Complaints about NYC subway safety

*Figure 1 – Non-compliant ADA condition
72nd Street Station*

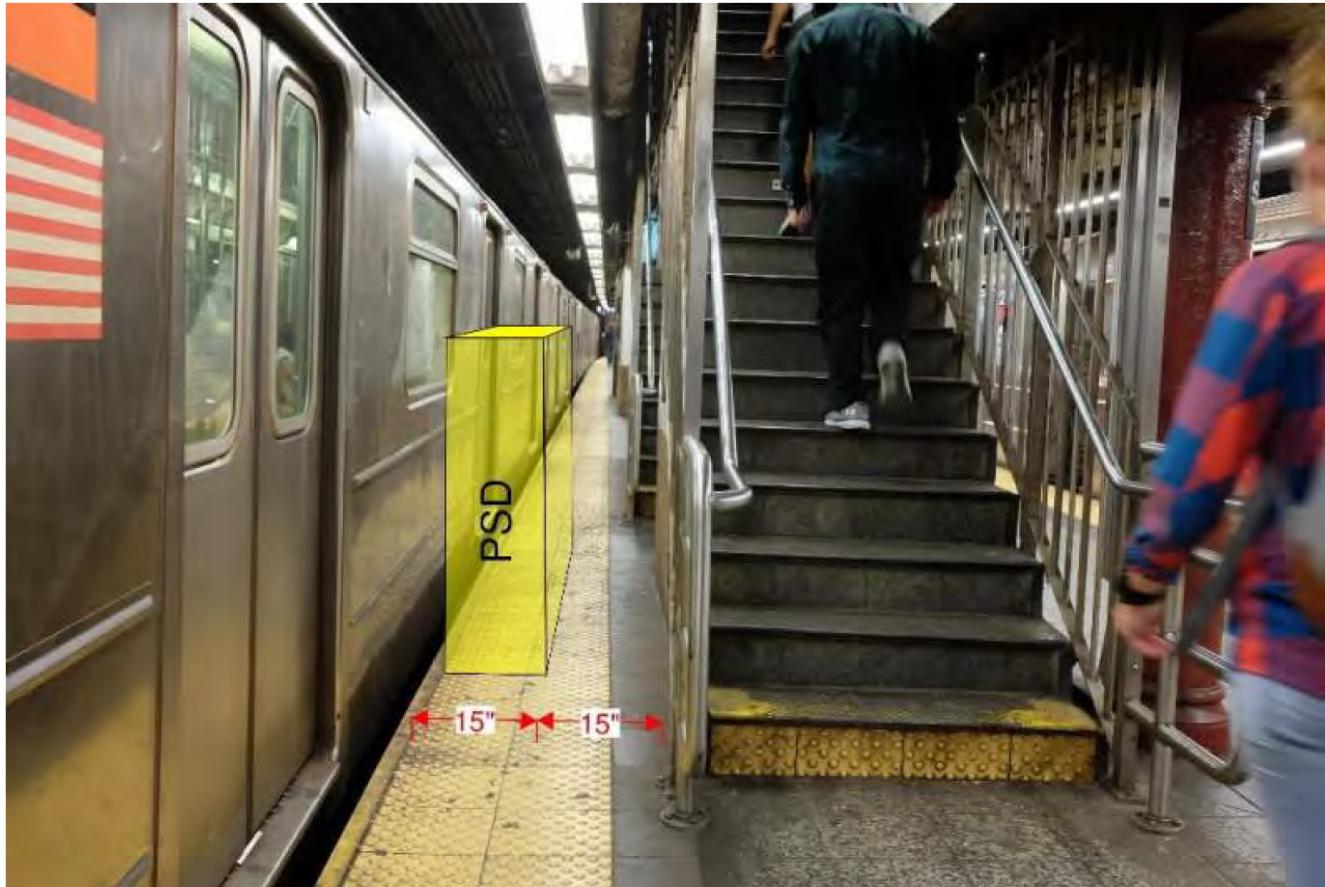
Another example is 72nd street. It is 30 inches without the platform screen door (PSD) and ADA requires 36 inches. If someone tried to roll a wheel chair through that section they would be on the yellow recommended no-step line.
